**WNE3 - Replacing Front Seat-Belt Buckle (Workshop Campaign)**

Model Line: **Taycan (Y1A/Y1B/Y1C)**

Concerns: **Belt buckle on driver's and passenger's side**

*Installation position of front belt lock*

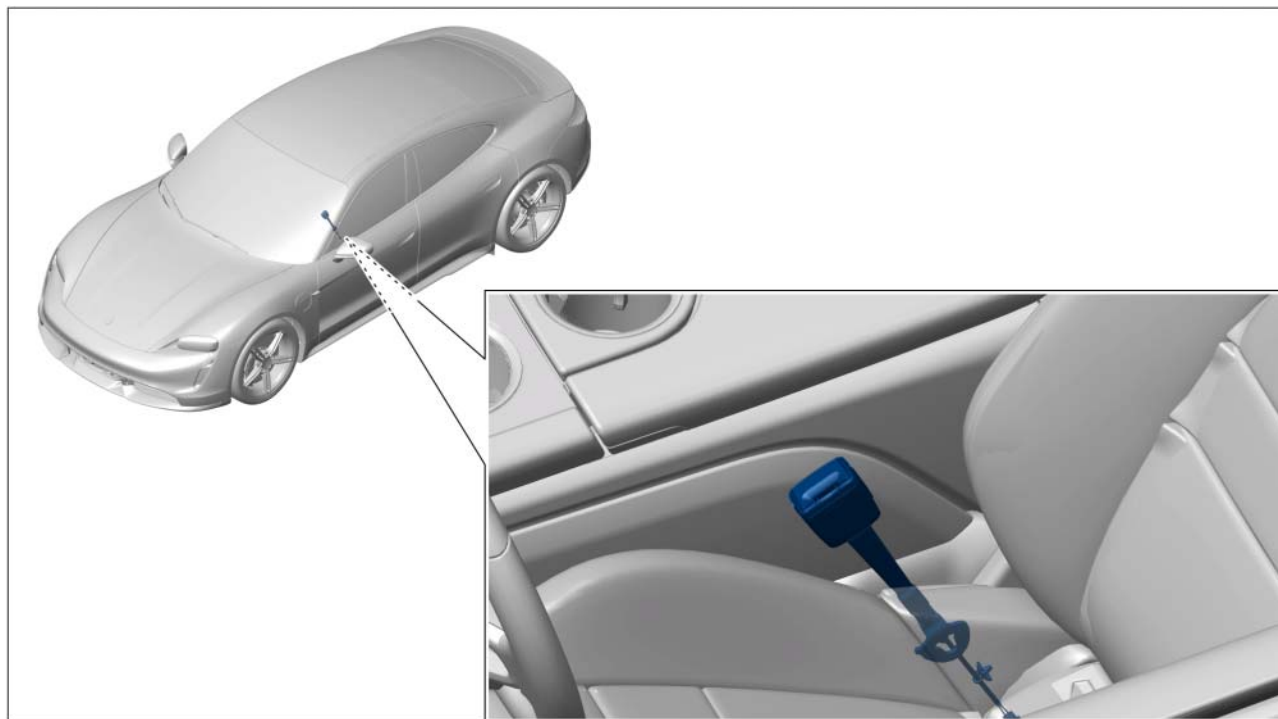
Information: **There is a possibility that the cable length on the belt buckle switch on the driver's and passenger's side is not sufficient on the affected vehicles.**

This can cause a cable break over the extended service life of the seat height adjustment system.

Action required: Replace front seat-belt buckle.
